Appendix G
Field Change Requests

RE: ADEM Review and Concurrence: *Field Change Request #23 to the Munitions Response Site 9 (MRS-9) Site Specific Work Plan, McClellan, Anniston, Alabama;* submitted July 10, 2014
Fort McClellan, Calhoun County, Alabama
Facility I.D. No. AL4 210 020 562

FIELD CHANGE REQUEST (FCR) FORM McClellan: Revision 1 to Final Program Level Work Plan

Figure 10-1
MRS-9 UOP Designation

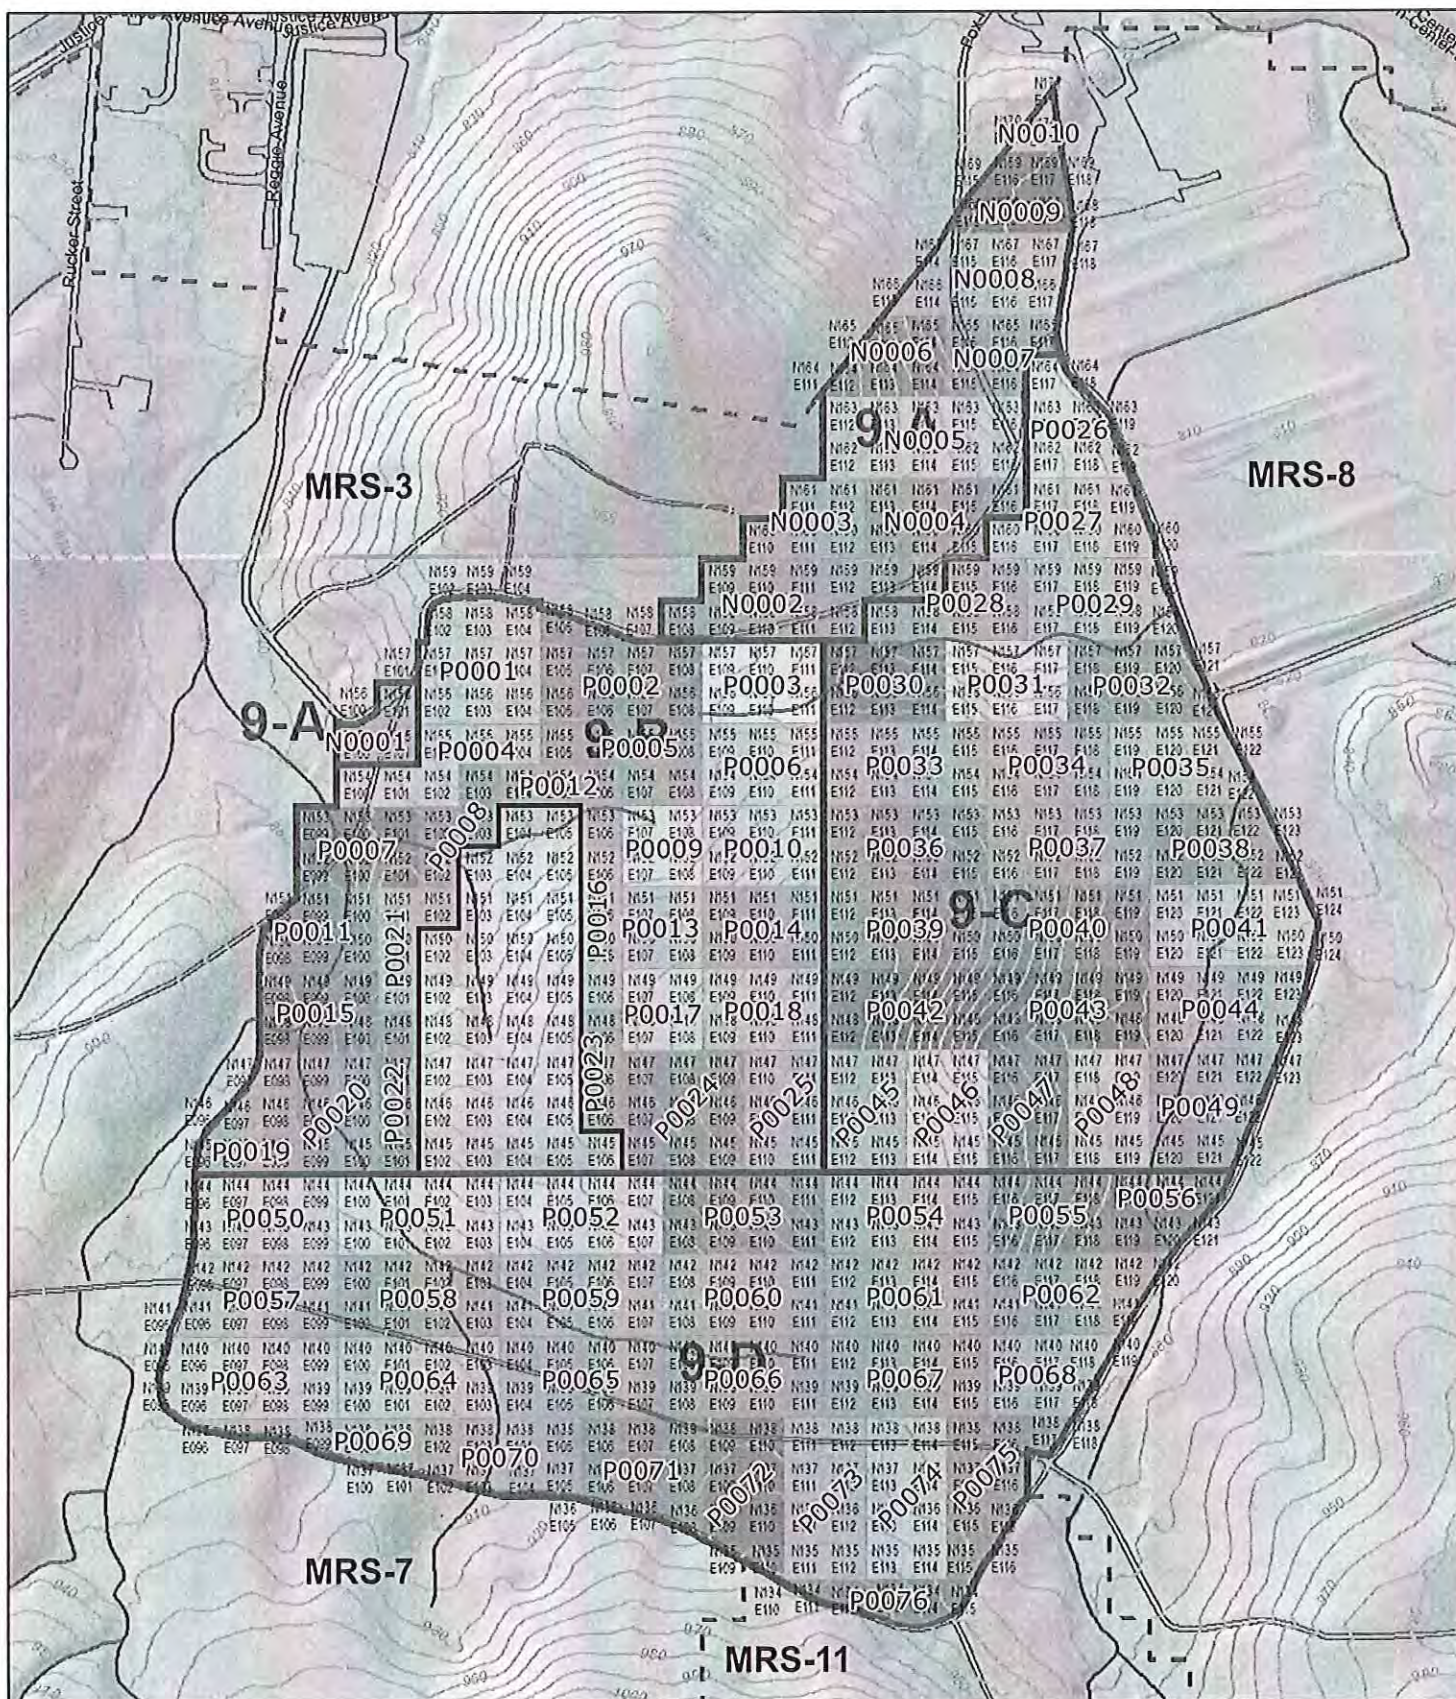
1. Description (Items involved, submit sketch, if applicable): (Use continuation sheet if necessary)
MRS-9, tract 9B Units of Production (UoPs) in the MRS-9 Site Specific Work Plan (SSWP) are revised in preparation for mechanized sifting clearance of the central impact area. Figure 10-1 (MRS-9 UoPs) and Section 10.7.2 of the SSWP are revised.

A stand-alone appendix (new Appendix G) to the SSWP addressing the proposed mechanized sifting operation will be submitted to ADEM under separate cover. For the 33 grids comprising the central impact area, QC for the MEC clearance operation will be performed essentially on a grid by grid basis (each grid will be its own UoP) instead of grouping them into multi-grid UoPs. The 24 grids immediately bordering the central impact area have been regrouped into smaller UoPs.

2. Reason for Change (Use continuation sheet if necessary)
For the central impact area in MRS-9 tract 9B (former Range 16) which is densely contaminated with MEC and MD, the clearance to one foot remediation will be more efficiently addressed via a mechanized sifting operation.

Appendix A (Figures) - Figure 10-1 MRS-9 UoP Designation (attached)

Section 10.7.2 Units of Production.
A UoP is a contiguous number of grids that are grouped together into a manageable unit that can then be tested by the QC process. The size of a UoP will be variable and may depend on a variety of factors such as the number of targets in the area (target density), end land use, environmental characteristics including topography, vegetation, noise, personnel, detection instrument used, area investigated by which UXO team(s), etc. It is preferable for QC that, where practical, distinct teams should be associated with each UoP. It is anticipated that a UoP will consist of one to ten-grids that are 100 ft x 100 ft in size (except for partial grids).

The UoPs will initially be grouped together based on their location to one another with the overriding factor being their end land use. However, this initial grouping may be modified as other factors described above and the number of targets in each grid (and surrounding grids) may override the initial "best guess" as to how to group the grids together. Therefore, final UoP grouping will be done by the Project Manager and GeoQCS only after the end land use and the number of targets in the entire area is known. Thirty three (33) grids in tract 9B have been determined to constitute a heavily contaminated impact area which will be more efficiently prosecuted by a mechanized sifting operation which will be described in a stand-alone Appendix G (to be submitted under separate cover). Each of the 33 grids in the central impact area will be considered its own UoP for clearance QC purposes. The revised UoPs for MRS-9 are shown in Figure 10-1 (Appendix A). Changes to the initial UoPs and their rationale will be documented in Removal Action Report.
